MONTGOMERY COUNTY PLANNING DEPARTMENT
THE MARYLAND-NATIONAL CAPITAL PARK AND PLANNING COMMISSION

MEMORANDUM

REVIEW TYPE: Preliminary Plan of Subdivision

PROJECT NAME: Spring Meadows
CASE #: 120090200
REVIEW BASIS: Chapter 50, Montgomery County Subdivision Regulations

figure 1

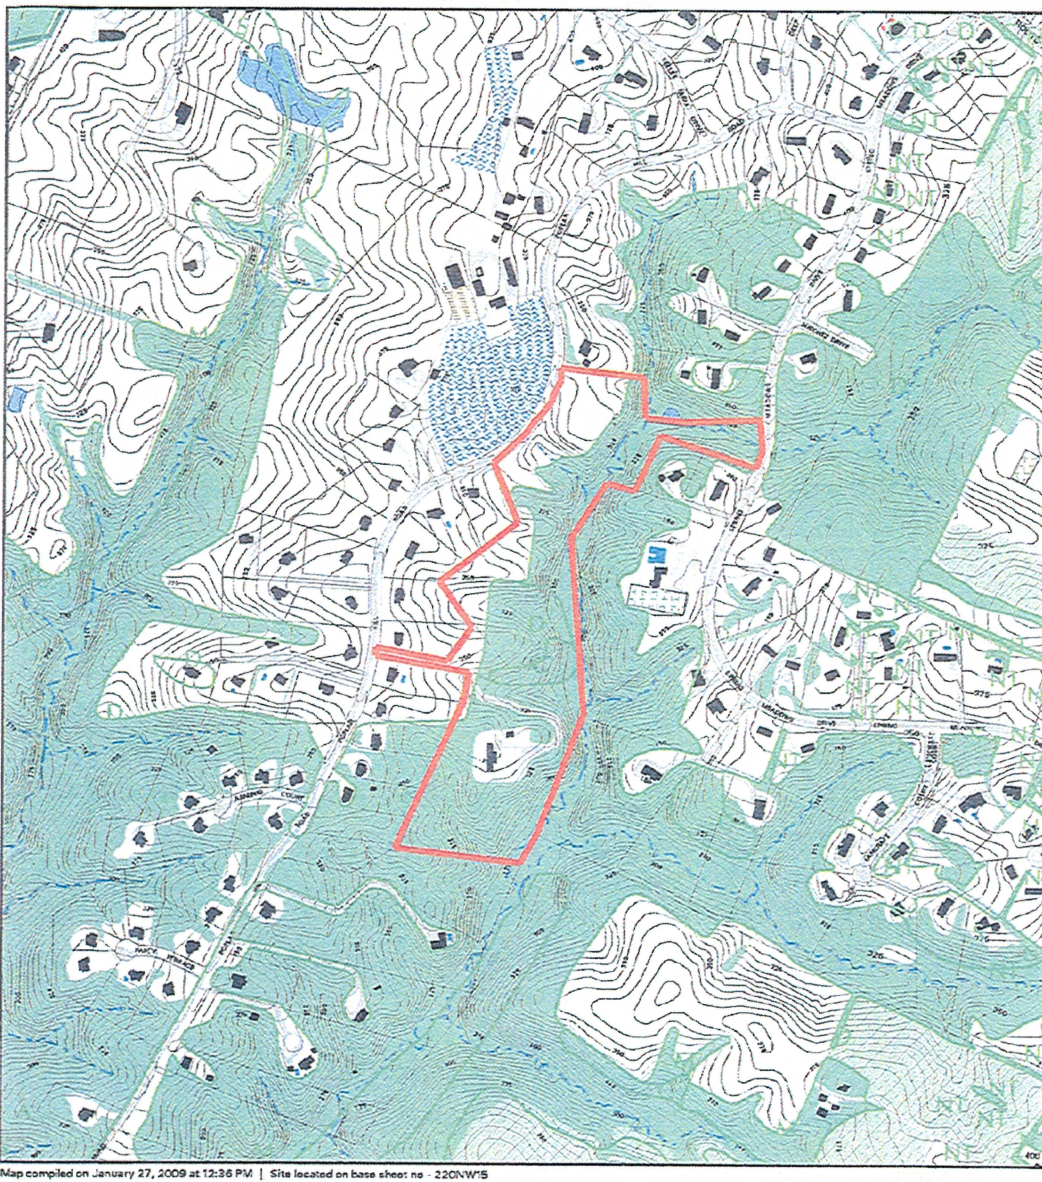
The subject property "Property" or "Subject Property" is identified as Lots 52 and 64, Block C in the Spring Meadows Subdivision. The Property, which is zoned Rural Cluster (RC), is located on the east side of Poplar Hill Road, approximately 2,500 feet south of the intersection with Spring Meadows Drive in the Potomac Subregion Master Plan. Lot 52 is 22.8 acres and Lot 64 is 20.0 acres, totaling 42.82 acres and were created by a plat recorded in 1986.

Lot 64 currently has a house on it, Lot 52 is vacant. Lot 64 has frontage on Poplar Hill Road via a pipestem while Lot 52 has considerable frontage on Poplar Hill Road. The eastern

border of the Property is bounded by a Use-I tributary to the Lower Great Seneca creek. The Property has numerous on-site wetland areas and 15.78 acres of stream valley buffer.

A review of the original plats for the Spring Meadows Subdivision reveals that these two lots are part of the open space for the development of Spring Meadows which developed under the optional method of the Rural Cluster zone. Optional cluster development in the RC zone is required to provide 60% of the entire subdivision as open space which can include easements on private lots with houses. The two lots, and nine other large lots all in excess of 20 acres, appear to comprise the open space for the development although they do not have any open space easements associated with them.

Figure 2

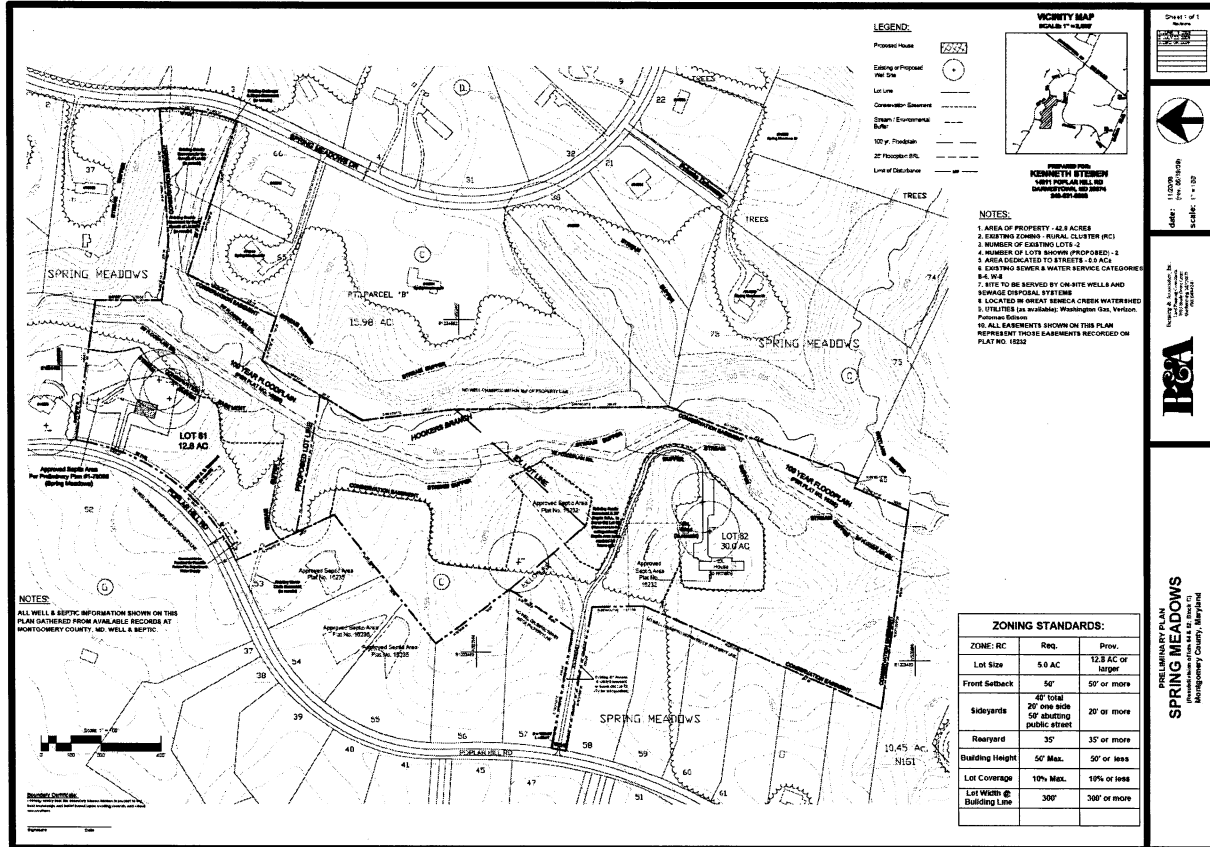
The application proposes to adjust the lot line between the two lots (52 and 64) that comprise the Subject Property. No new lots are created by this application, however, because the lots will have new configurations, a new record plat will be required and the lots will receive new lot numbers. The Property will also be required to meet the requirements of the Montgomery County Forest Conservation law; therefore, forest conservation easements will be placed on the plat. Based on the Planning Board's recent interpretation that the resubdivision criteria does not apply to the agricultural zones, such as the Rural Cluster zone this application is not subject to a resubdivision analysis.

Both lots are currently under common ownership but the Applicant wishes to ensure that any future house location on the vacant lot is farther removed from the existing house than would be possible given the current lot configuration. Under this proposal, the new house location would be located to the far northern reaches of the Subject Property on proposed Lot 81. A new septic reserve area has been approved for this lot and located to accommodate the new house location. The existing septic reserve area that was approved for this house will be retained on the occupied lot and could be used for a future guest house as an accessory structure to the existing home; both to be located on proposed Lot 82. Attachments 1 and 2 best illustrate the existing and proposed lot patterns.

For this application, staff finds that the requirement to place 27.33 acres of the 42.81 acre site in a Category I forest conservation easement meets the 60% open space requirement in the RC zone. Staff has further considered that, of the 42.81 acre tract, 15.48 acres (41.88ac - 27.33ac) will no longer be considered open space under current standards which might affect the open space that was envisioned in the original approval. Staff's review of the existing subdivision reveals that ample open space opportunities exist beyond the 11 lots that originally comprised the open space. There are streams and stream buffers located on the smaller lots that would offset the loss of 15.48 acres had the entire subdivision been before the Planning Board for consideration. Staff concludes there to be no net loss of open space, and that

RECOMMENDATION: Approval, subject to the following conditions:

- 6) Existing viewshed easements for adjacent Lots 65 and 66 shall be shown on record plat for proposed Lot 81.
- 7) The certified preliminary plan must contain the following note: "Unless specifically noted on this plan drawing or in the Planning Board conditions of approval, the building footprints, building heights, on-site parking, site circulation, and sidewalks shown on the preliminary plan are illustrative. The final locations of buildings, structures and driveways will be determined during the building permit process. Please refer to the zoning data table for development standards such as setbacks, building restriction lines, building height, and lot coverage for each lot. Other limitations for site development may also be included in the conditions of the Planning Board's approval."
